service bulletin

No. 93-9

A. NEW REVERSE GEAR 43-824109 AND THRUST SPACER 23-824108

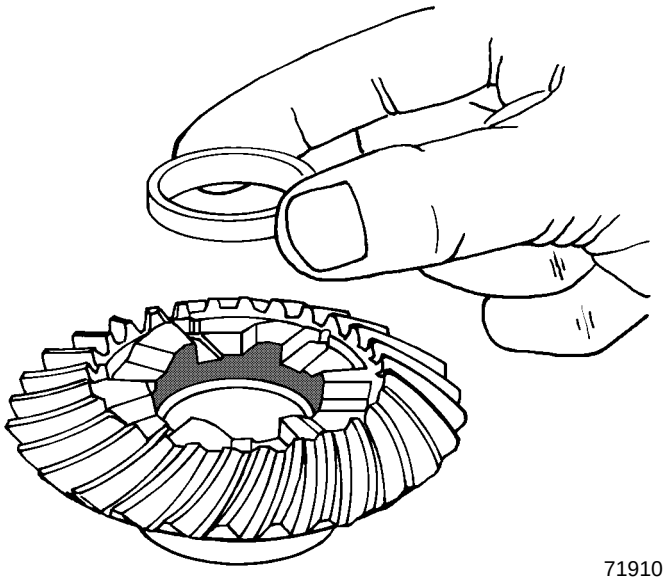
The reverse gear has had a machining change to accommodate for a thrust spacer to eliminate wear between the propeller shaft at the collar on the splined area of the shaft and the gear.

43-824109A1 Reverse Gear Kit which includes the spacer with the gear.

When installing the new gear it may be necessary to replace the prop shaft if the collar on the shaft at the aft end of the clutch spline area is worn and or discolored from wear.
